ENGINEERING BASE (SWS 2)

AMIDON IMPROVEMENTS
 SWS LINE 3
 WICHITA, KANSAS

SHEET 27 OF 133

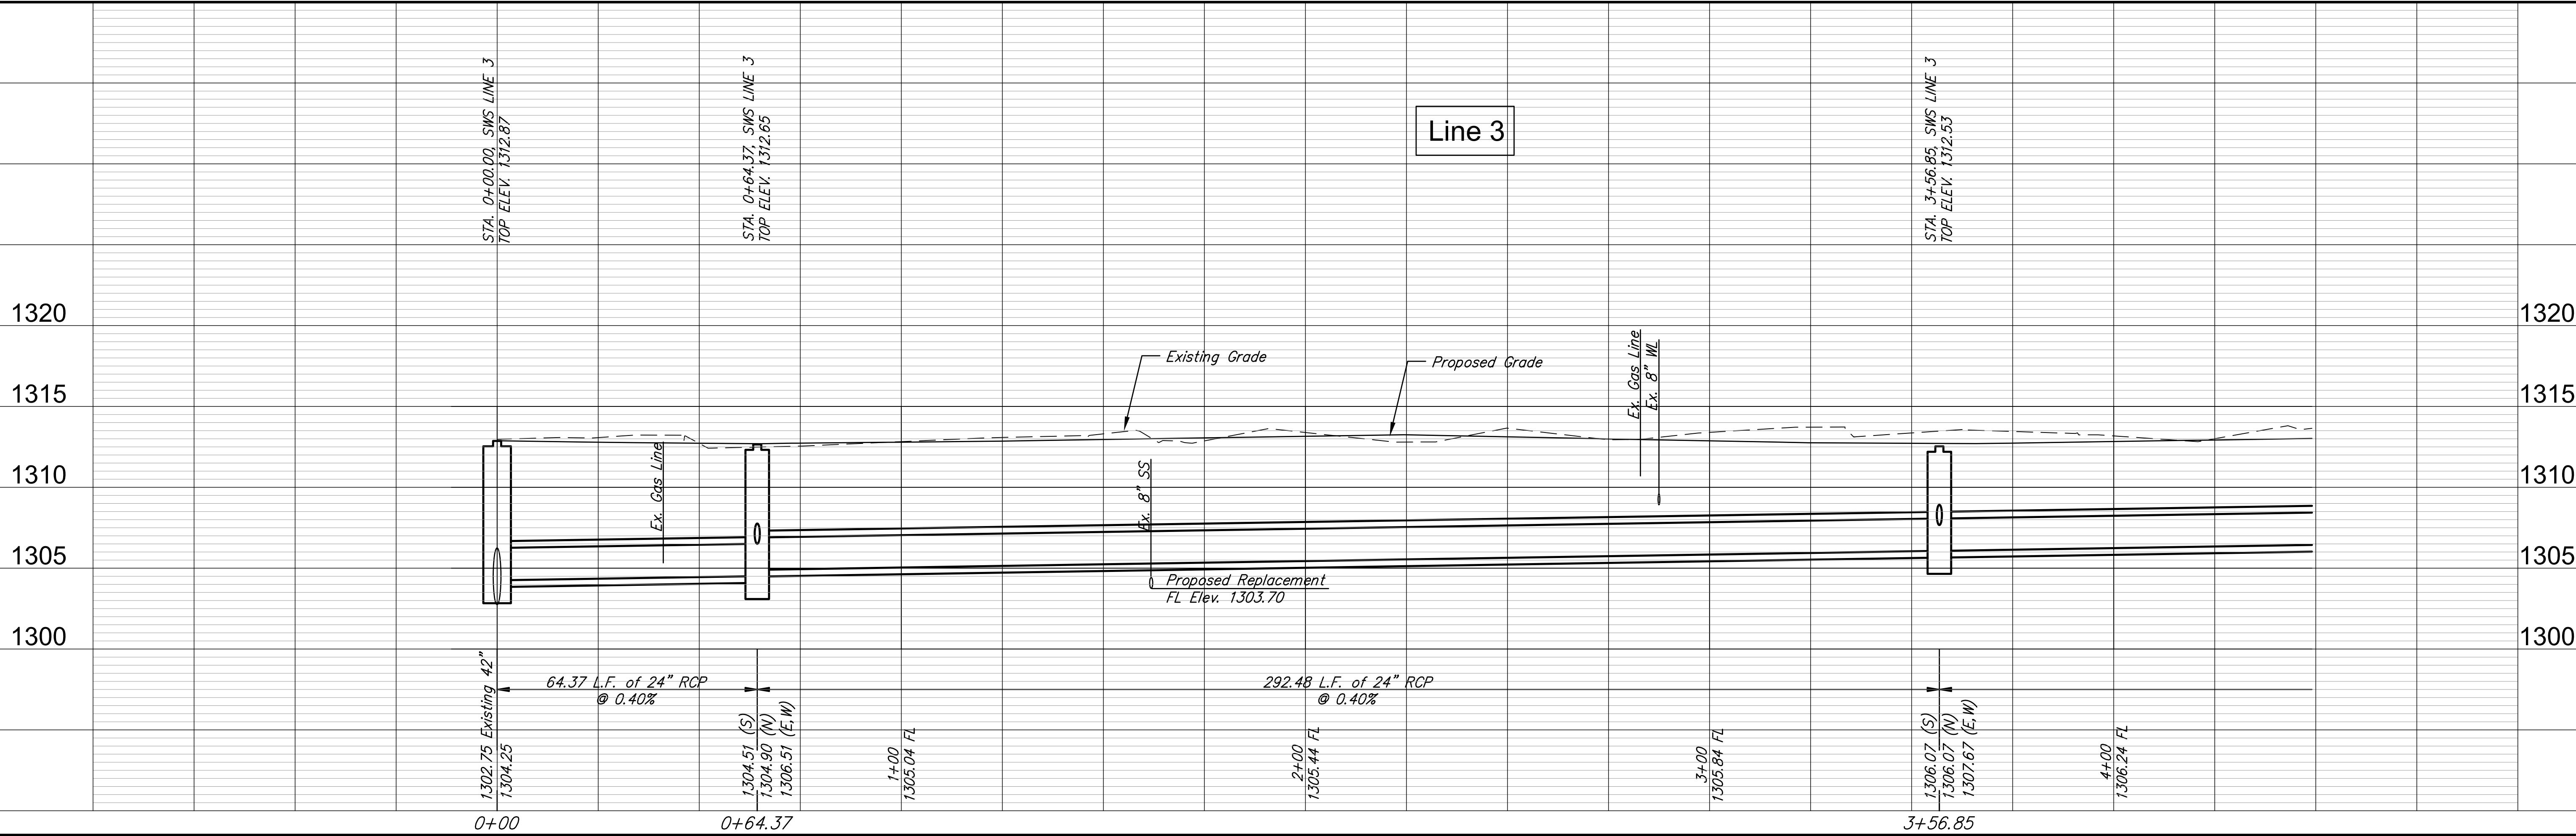
N 1700850.94 E 1641304.72
 STA. 0+00.00 SWS LINE 3=
 STA. 0+00.00 SWS LINE 3A
 BL STA. 37+74.45, 21.97' LT
 CONSTRUCT STD. TYPE P MH (6' DIA.)
 OVER EXISTING 42" RCP
 Moved 4'SW due to WL conflict.
